Presentation to the ACRS Subcommittee

Safety Review of the Vogtle Early Site Permit Application

October 24, 2007

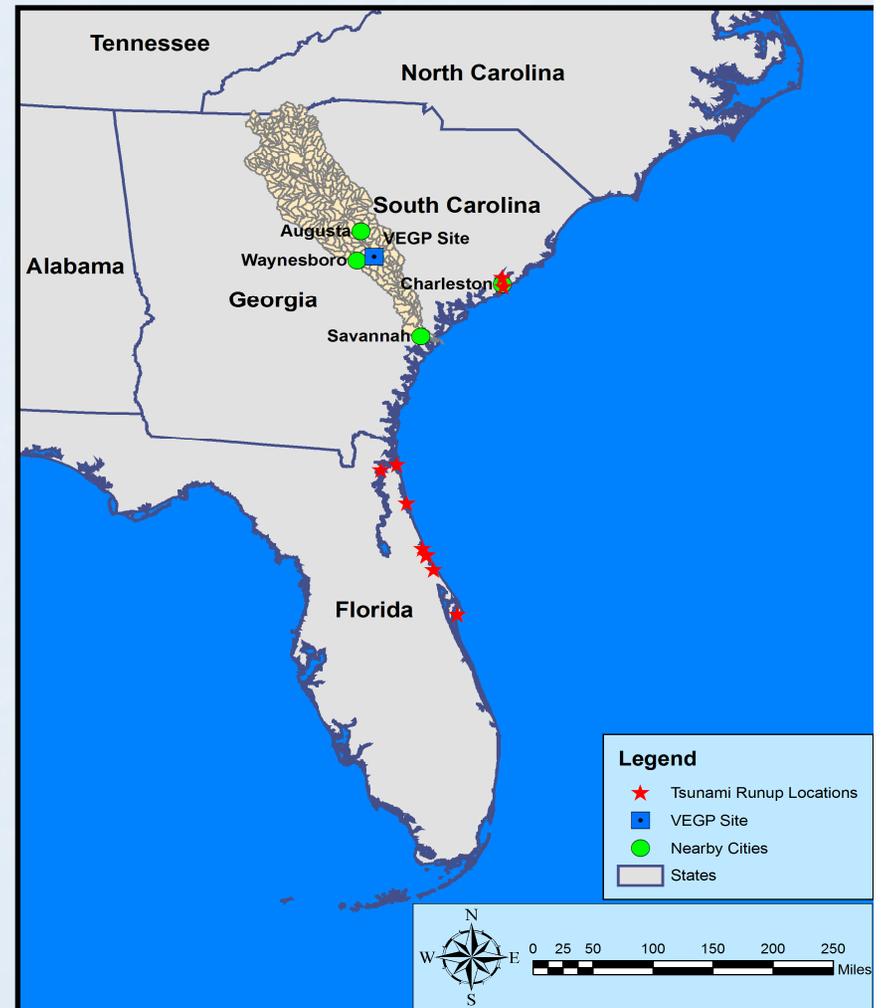
- Staff reviewed groundwater characteristics and data provided by the applicant
 - Staff determined that applicant should provide an improved and complete description of the current and future local hydrological conditions, including alternate conceptual models, to demonstrate that the design bases related to groundwater-induced loadings on subsurface portions of safety-related SSCs would not be exceeded; alternatively, the applicant can provide design parameters for buoyancy evaluation of the plant structures – **Open Item 2.4-3**

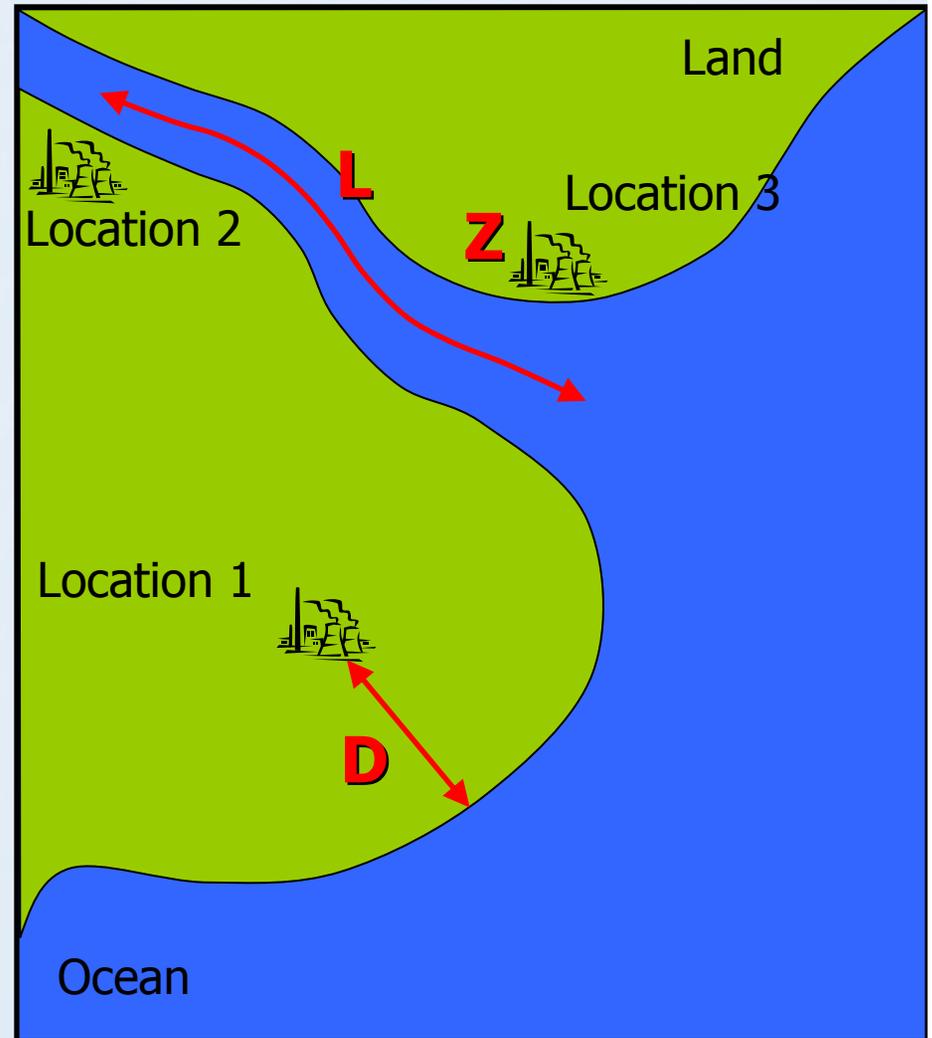
- step 2: site screening
 - The DLZ rule
 - D: horizontal distance, L: longitudinal distance along river or stream from estuary, and Z: elevation of the site
 - The Vogle ESP site: 100 mi inland from the coast, approximately 150 river miles from the estuary, and at an elevation of 220 ft MSL
 - A tsunami would need to inundate 100 mi inland and run up to 220 ft MSL, and a tidal bore would need to travel 150 mi upstream and reach 220 ft MSL
 - In US, tidal bores occur in Cook Inlet, Alaska
- step 3: comprehensive THA
 - Not needed
